December 14, 2007

Power Steering Reservoir Cap

MODELS AFFECTED: 2008 BBCV Vision

Old Design

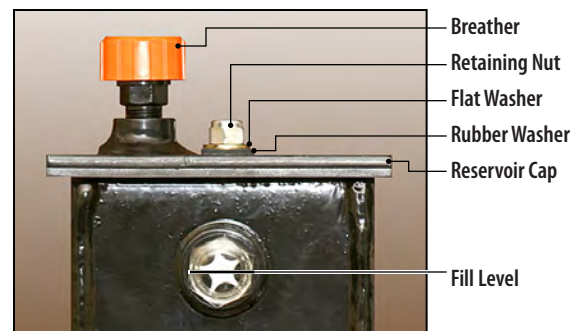
Power Steering Reservoir Cap allows fluid leak.

Replace the existing reservoir cap with the newly designed reservoir cap.

- 8** Install new Reservoir Cap w/gasket, rubber washer, flat washer and retaining nut supplied in kit (Blue Bird Part #0126305). Torque retaining nut to 10 ft. lbs.

CAUTION Do Not apply any type of gasket sealant.

- 9** Install original Breather in new Reservoir Cap.
- 10** Start engine and steer bus full left to full right 5 - 6 times.
- 11** Check Reservoir Cap and Breather to ensure leaks have been resolved.
- 12** Recheck fluid level in site-glass.
